4.3. Intersection with Veterans Parkway

Table 13. Safety Findings for Elma G. Miles and Veterans Parkway Intersection

Figure 29: Pattern of Rear End Crashes in Channelized Right-Turn Lanes (2012-2016)

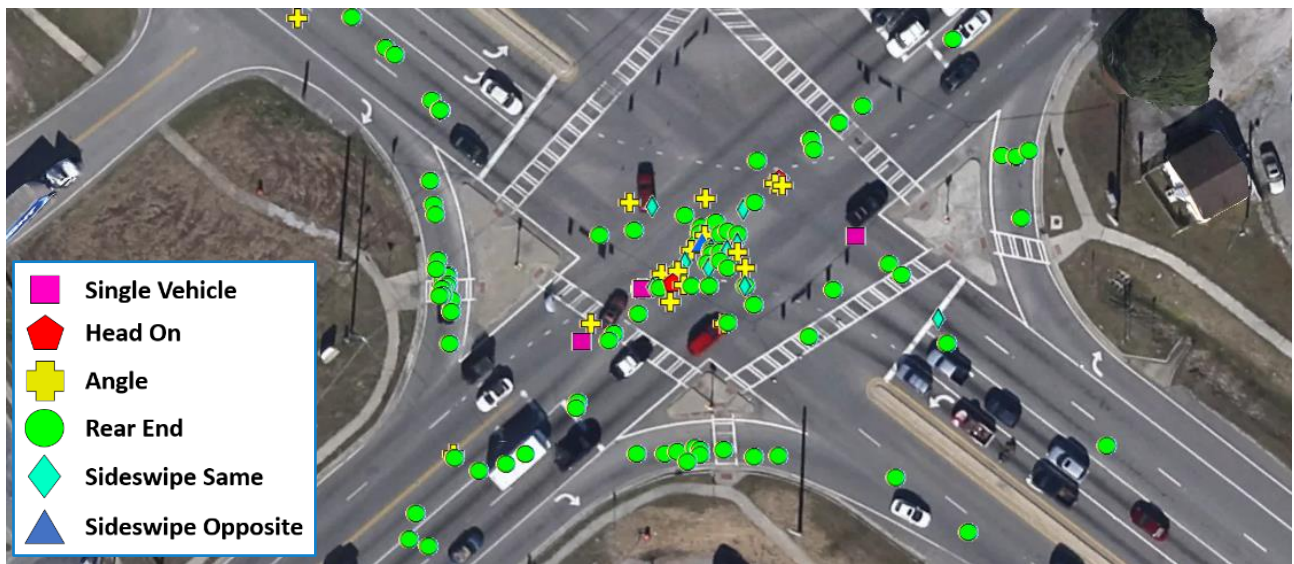
The existing raised concrete channelizing islands were implemented with a higher deflection angle that can result in drivers having to look over their shoulder to observe conflicting traffic. As a result, a pattern of rear end crashes within the channelized right-turn lanes was observed during the five-year study period (Figure 29).

The implementation of 30-60-90 degree raised concrete channelizing islands would represent a significant improvement over the existing condition, helping to address the pattern of rear end-type crashes shown in **Figure 29**. Consolidating driveways within the functional area of the intersection, specifically the gas station driveways located on the northern leg, would directly help to address the crash pattern shown in **Figure 31**.
